Building 'D' Massing & Articulation

April 5, 2010

Building D Comments from DRB on 15 March:

Design Guideline Section

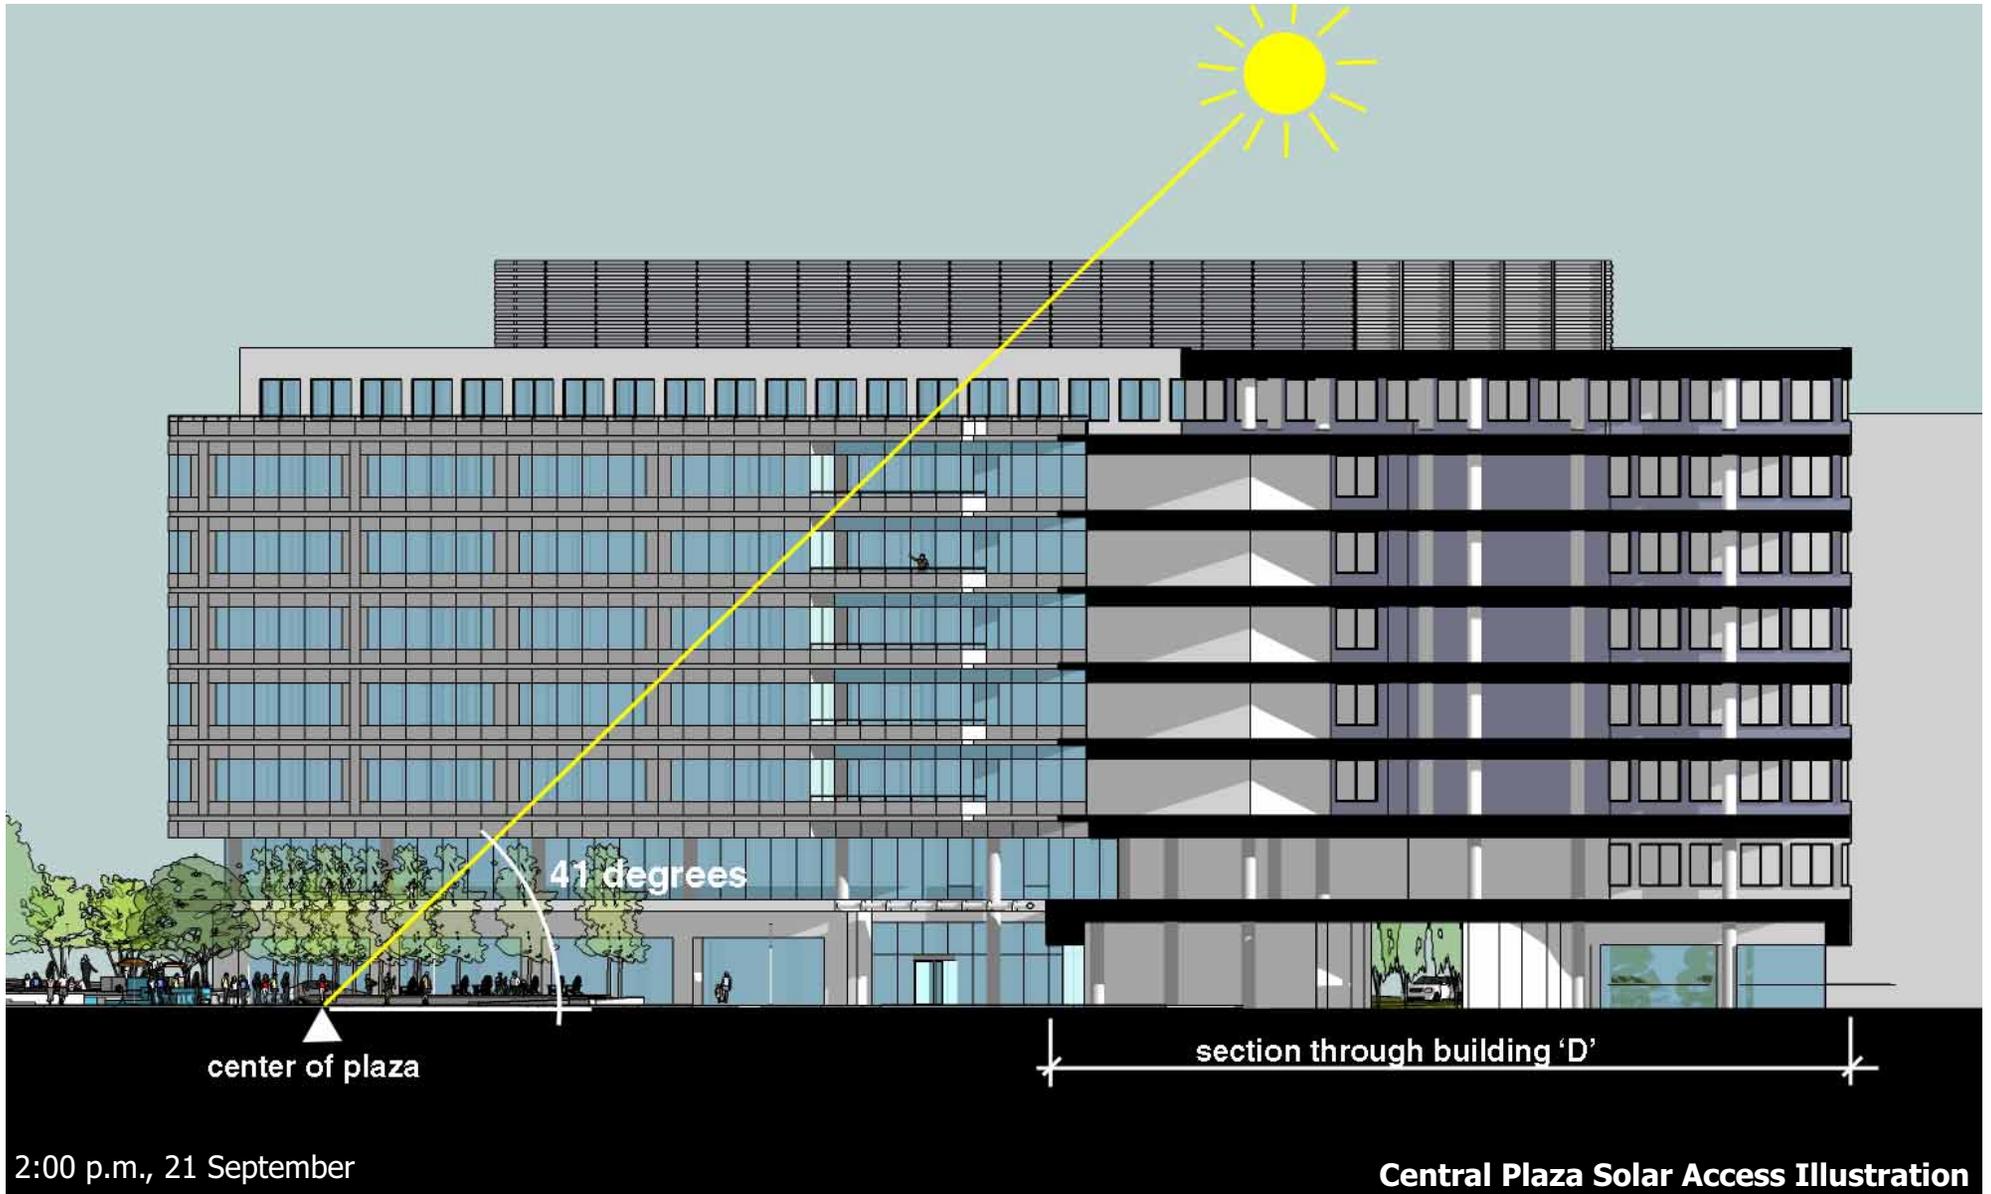
- 1. General Comments** – Too large and massive overall; breakdown the horizontal pieces,
- 2. West Elevation** –Blue highlighted section of the building too visually prominent. Move it south, step away from the plaza to reduce visual impact (see drawings on page 39 and page 43 of 3/15/10 submittal to the DRB).
- 3. North Elevation** – Eastern portion of the top floor should be moved back to match the step back of the western portion (see drawing on page 38 of 3/15/10 submittal to the DRB).
- 4.** Do a drawing that shows that the building meets the 41 degree angle requirement in Design Guideline 13.d.3 (page DG-29 of the Master Plan and Design Guidelines).

In order to maximize the amount of sunlight in the central plaza, building B should be contained under a line at a 41 degree angle measured from the center of the plaza, per diagrams above.
